Re: Belmont Public Library - Design and Site Plan Review Application, Supplemental Information #2, Revisions to Contractor Access to Golden Bowl

## Belmont Public Library

SUPPLEMENTAL INFORMATION FOR OCTOBER 3, 2023 HEARING

Revised September 29, 2023

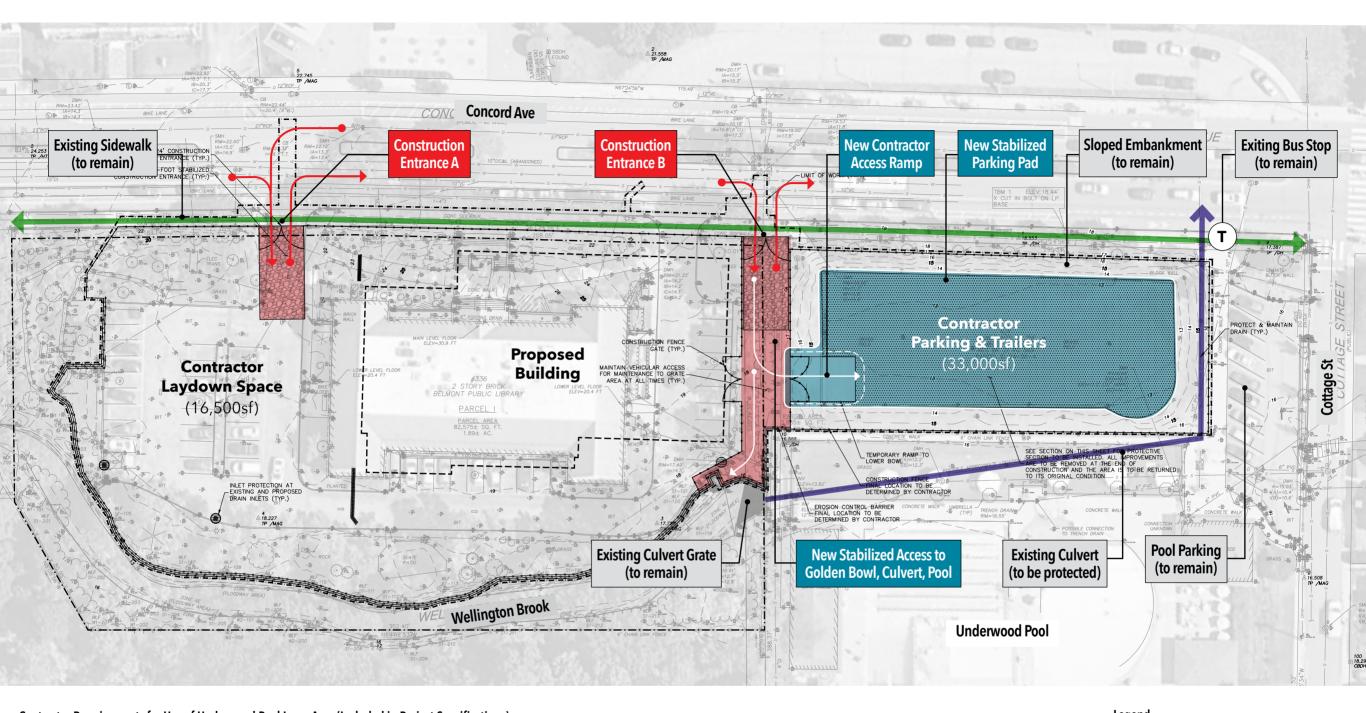
Following submission of Supplemental Information package #2 on September 27, 2023, additional revisions have been made to *Item 1. Contractor Access to the Underwood Pool 'Golden Bowl' at 320 Concord Ave.* The revised contractor access plans are enclosed. The updated plans clarify the following:

- Contractor point of access into the bowl;
- DPW access from Concord Ave to the Wellington Brook culvert grate;
- Extent of the bowl area that will be modified and/or stabilized for contractor parking (i.e. sloped embankments will not be disturbed);
- Cross-section of stabilized surface build-up at existing lawn areas used for contractor parking;
- Maintenance of public sidewalk access in front of library during construction.

- 1. Construction Management Plan shall be submitted for review and approval by the owner and project team. The plan shall define construction entrance locations, staging areas, times of use, stabilization of the Golden Bowl and other temporary conditions proposed by the contractor for the library property and Golden Bowl.

- Construction entrances shall be located on Concord Ave. Access from Cottage St is not permitted.
- 3. Golden Bowl shall be stabilized\* for contractor vehicle use during construction and restored to its existing condition at the conclusion of construction.

- I. Fencing with screening shall be provided around the full perimeter of the temporary parking area.
- 5. Existing underground culvert shall be protected and the culvert grate shall remain accessible for maintenance.

- Hours of construction vehicle arrival and departure shall be coordinated with school schedules.
- 7. Sidewalk access shall be maintained during the majority of construction (temporary closures will be required for utility work and sidewalk replacement).

- 8. No alteration to the existing Underwood Pool parking.
- P. No alteration to the existing bus stop at the corner of Cottage St.

- \* Stabilized Surface at the Golden Bowl will include:
- 1. Removal and/or stockpiling of existing loam
- 2. Installation of stabilized sub-base including base layer of protective geo-fabric + 4-6" clean stabilized stone + top layer of protective geo-fabric
- 3. Installation of 2" dense graded driving/parking surface
